Access Compliance Report Public Rights-of-Way (Curb Ramps)

Main Street: CARTLEN_DR Cross Street: TABAH_LN Location: NE

ADA ID: RPAT210917130056 Ramp Type: Type 1 - Perpendicular Diagonal Initial Pass/Fail: Fail Overall Compliance: No Severity Score: 15

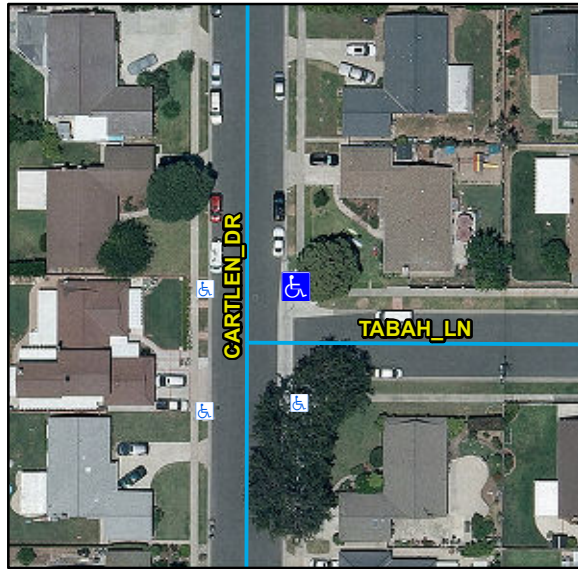
Compliance	Description	Data	Compliance	Description	Data
N/A	Ramp Length (in)	59	N/A	Flare Type LT	
Yes	Ramp Width (in)	48			N/A
No	Ramp Run Slope (%)	8.6	N/A	Flare Slope LT (%)	N/A
Yes	Ramp Cross Slope (%)	0.1	N/A	Flare Traversable LT	N/A
N/A	Landing Present	N/A	N/A	Flare Type RT	
N/A	Landing Length (in)	N/A			N/A
N/A	Landing Width (in)	N/A	N/A	Flare Slope RT (%)	N/A
N/A	Landing Run Slope (%)	N/A	N/A	Flare Traversable RT	N/A
N/A	Landing Cross Slope (%)	N/A	N/A	DWS Provided	N/A
N/A	Landing Movement Obstructed?	N/A	N/A	DWS Contrast	N/A
	Landing Movement Type	N/A	N/A	DWS Length (in)	N/A
N/A	Landing Shared	N/A	N/A	DWS Full Width	N/A
N/A	Clear Space	Yes	N/A	DWS Offset Left (in)	N/A
N/A	Clear Space To Crosswalk (in)	N/A	N/A	DWS Offset Right (in)	N/A
N/A	Marked Crosswalk 1	No	N/A	Marked Crosswalk 2	No
	Crossing 1 Direction	W		Crossing 2 Direction	S
	Marked Crosswalk 1 Width (in)	N/A		Marked Crosswalk 2 Width (in)	N/A

N/A	Ramp Inside Crosswalk 1	N/A	Yes	Ramp Inside Crosswalk 2	N/A
	Crossing 1 Slope (%)	6.9		Crossing 2 Slope (%)	0.5
	Crossing 1 Cross Slope (%)	0.3		Crossing 2 Cross Slope (%)	1.7
N/A	Gutter Ponding	N/A	No	Curb Slope	6.5
Yes	Gutter Lip Height (in)	0		Road Run Slope (%)	0.3
N/A	Gutter Run Slope (%)	N/A		Road Cross Slope (%)	2.5
N/A	Gutter Cross Slope (%)	N/A			
Yes	Overall Surface Condition: Acceptable		Yes	Perp Joint Present	Yes
	Cross Gutter Present?	Yes		Spandrel Present?	Yes
	Replace Cross Gutter?	No		Replace Spandrel?	No

Remove & Replace Curb Ramp With Two New Directional Ramps or Equivalent.
